Access Compliance Report

Public Rights-of-Way

Intersection ID: 43492	Main Street: CHESLEY_DR	Cross Street: REDWOOD_VALLEY_LN	Location: NW
ADA ID: BC87E519DB83	Ramp Type: PerpDiag	Initial Pass/Fail: Fail	Overall Compliance: No
		Severity Score: 10

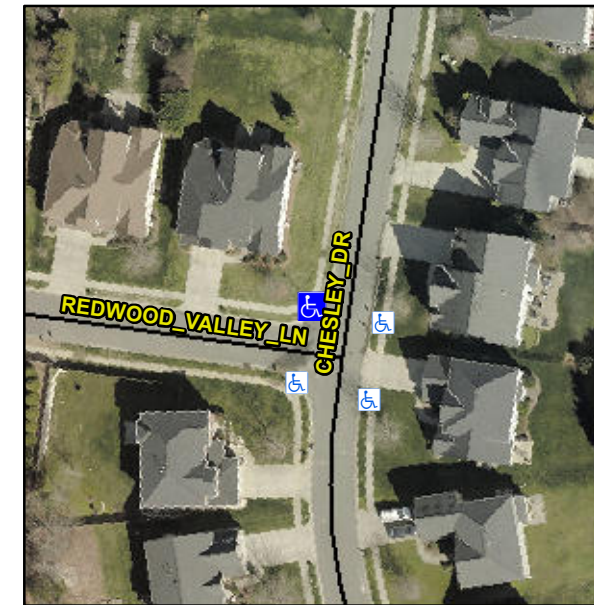
Not Found, R304.5.1, R304.5.3

Compliance	Description	Data	Compliance	Description	Data
N/A	Ramp Length (in)	45.0	Yes	Ramp Slope (%)	8.2
No	Ramp Width (in)	47.0	No	Ramp XSlope (%)	4.7
N/A	Flare Type LT	N/A	N/A	Flare Type RT	N/A
N/A	Flare Slope LT (%)	N/A	N/A	Flare Slope RT (%)	N/A
N/A	Flare Traversable LT?	N/A	N/A	Flare Traversable RT?	N/A
N/A	Landing Length (in)	N/A	N/A	DWS Provided?	N/A
N/A	Landing Width (in)	N/A	N/A	DWS Contrast?	N/A
N/A	Landing Slope (%)	N/A	N/A	DWS Length (in)	N/A
N/A	Landing X Slope (%)	N/A	N/A	DWS Full Width?	N/A
N/A	Landing Curb? (Y/N)	N/A	N/A	DWS Offset (in)	N/A
N/A	Shared Landing?	N/A			
N/A	Gutter Ponding?	N/A	N/A	Gutter Slope (%)	N/A
N/A	Gutter Lip Ht (in)	N/A	N/A	Gutter X Slope (%)	N/A
N/A	Painted X Walk1?	No	N/A	Painted X Walk2?	No
	X Walk 1 Direction	To SW		X Walk 2 Direction	To SE
N/A	X Walk 1 Width (in)	N/A	N/A	X Walk 2 Width (in)	N/A
	X Walk 1 Slope (%)	2.9		X Walk 2 Slope (%)	2.0
	X Walk 1 X Slope (%)	0.2		X Walk 2 X Slope (%)	2.0

Remove & Replace Curb Ramp With Two New Directional Ramps or Equivalent.
